ADDENDUM

Addendum No:	2	Project Number:	22-007
Project:	Gogebic Medical Care Facility Interior Renovations	Date:	05.25.2023

FIRST FLOOR REFLECTED CEILING PLAN

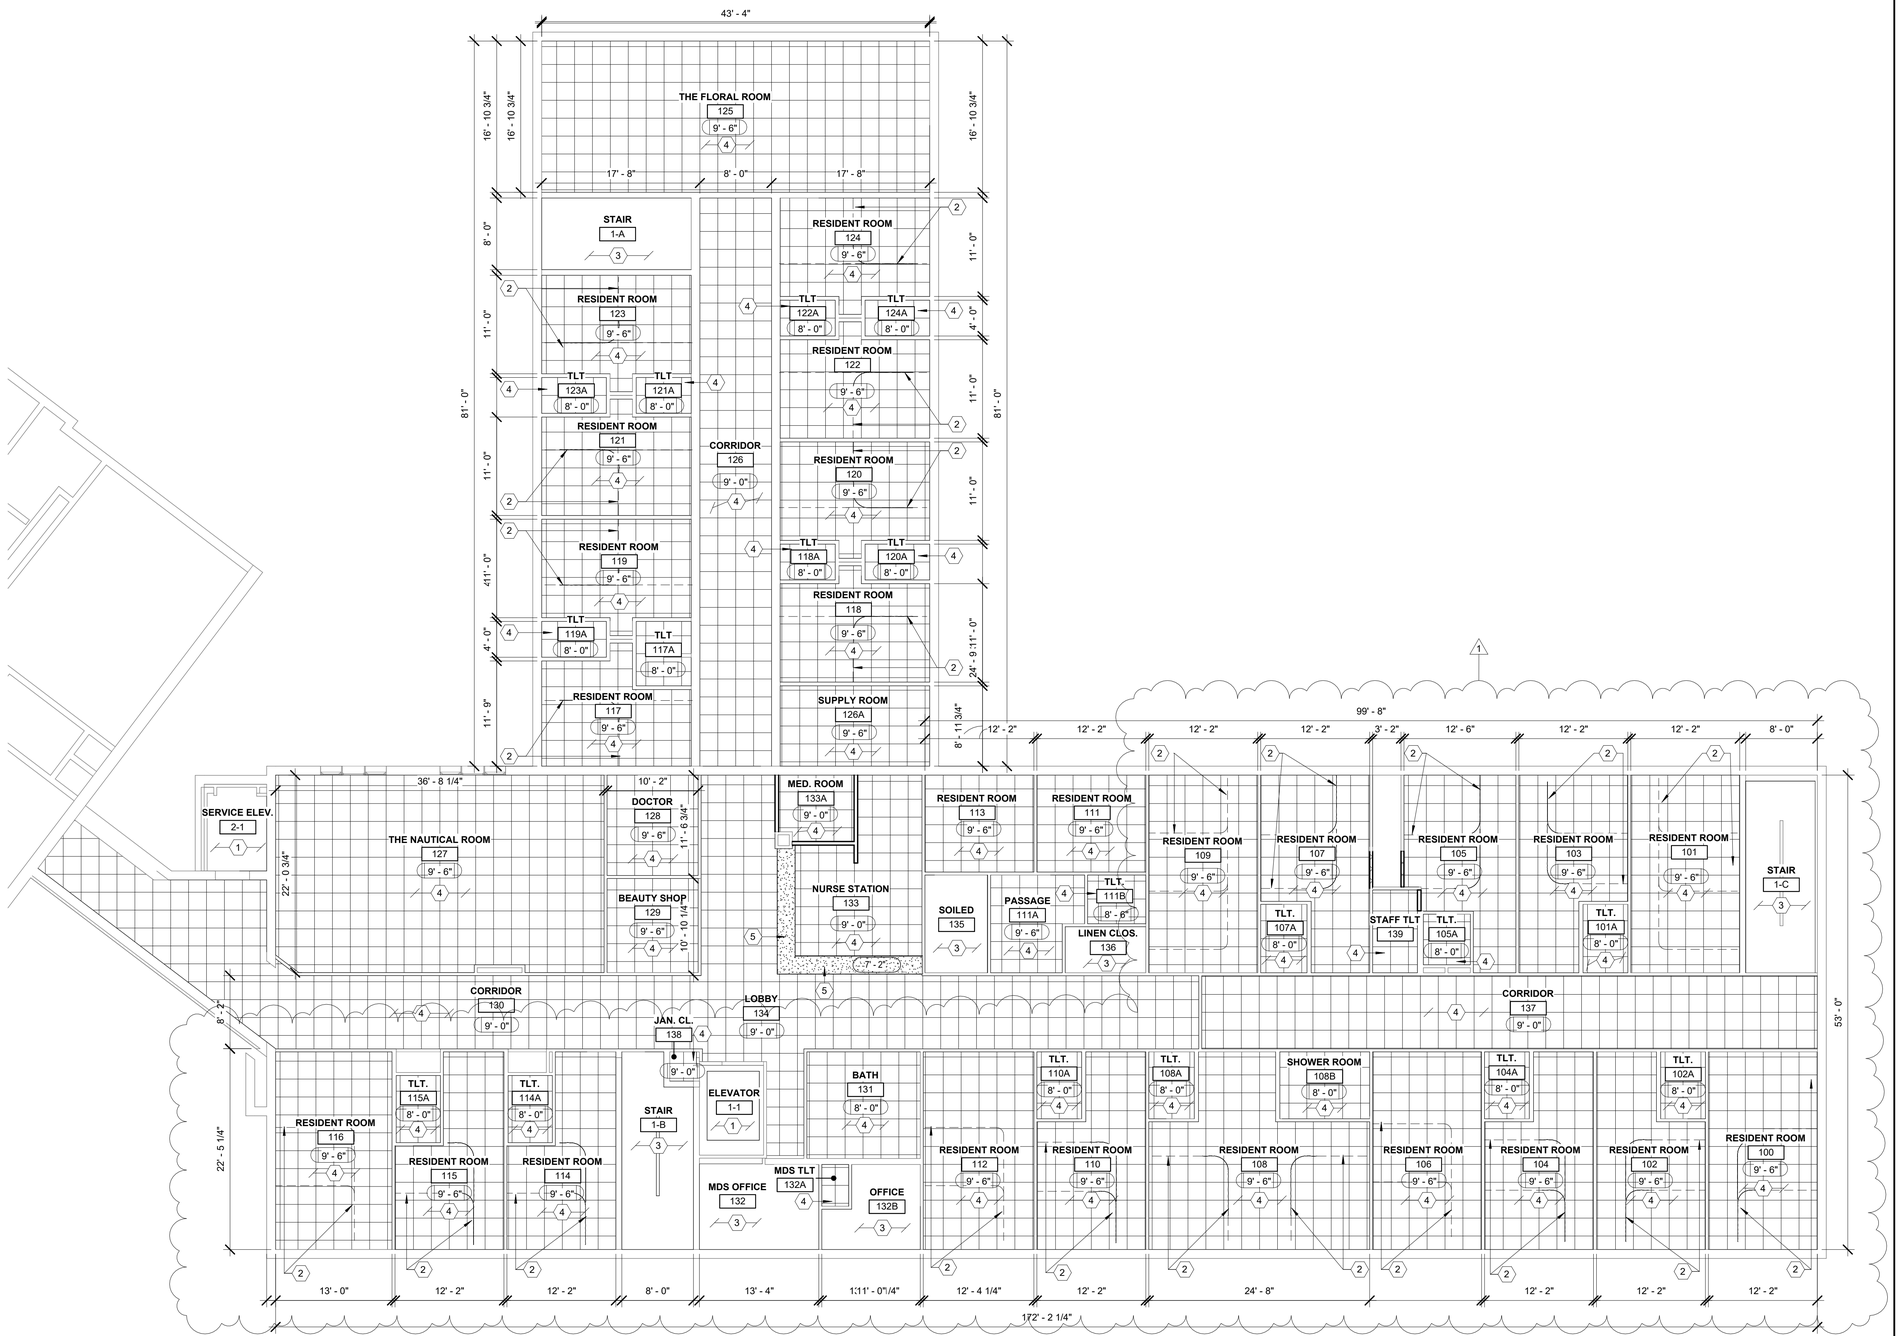
Item 1: Revise Curtain Track Systems from 3 residents to 2 in the following Resident Rooms: 100, 106, 112, 116, 216.

Revised Sheets: **A3.1, A3.2**
